Product Bulletin # CDS-009

# **ICDS Grapple Retention Retrofit Solution**

All the 7" to 9-5/8" ICDS tools regardless of the date of manufacture.

Figure 3

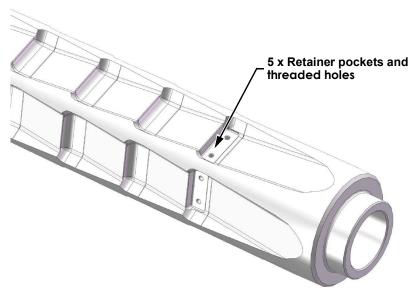
2. Modification of 'on-hand' Mandrel(s) – P/N: 17863, 17863-1 or 17863-2 – See Figure 3.

- Machine the slots, drill and thread the holes as per P/N: 5101917 Mandrel, 7" Modified for grapple retention.
- Refer to Appendix A for drawing 5101917.
- 3. Modification of 'on hand' Grapples (all grapple sizes 7" to 9-5/8") qty. 5 per set See Figure 4.

#### Grapple Retention Kit, 7" to 9-5/8" Grapples - Canrig P/N: 5101921

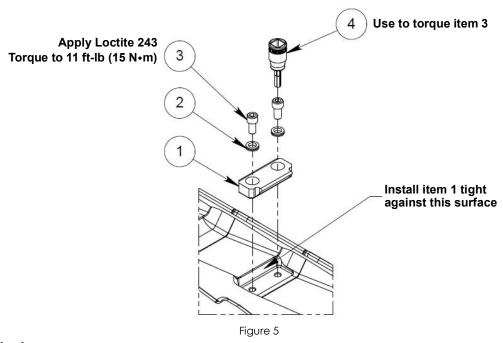
a. Procure P/N: 5101921 – Kit, Grapple retention, 7" to 9-5/8" grapples – from RIGLINE 24/7<sup>TM</sup>. The kit includes the following parts:

Appendix B – P/N: 5101919 – Grapple, 7" to 9-5/8", Modified for Retention

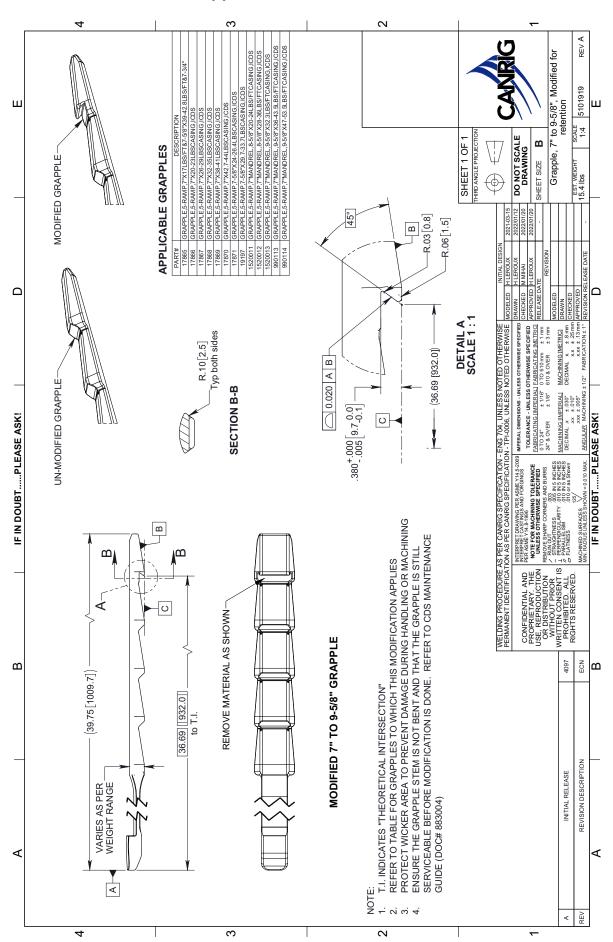
- If it is determined that the grapples are still serviceable, modify the grapples as per P/N: 5101919 Grapple, 7" to 9-5/8", Modified for retention.
- Refer to Appendix B for drawing 5101919.
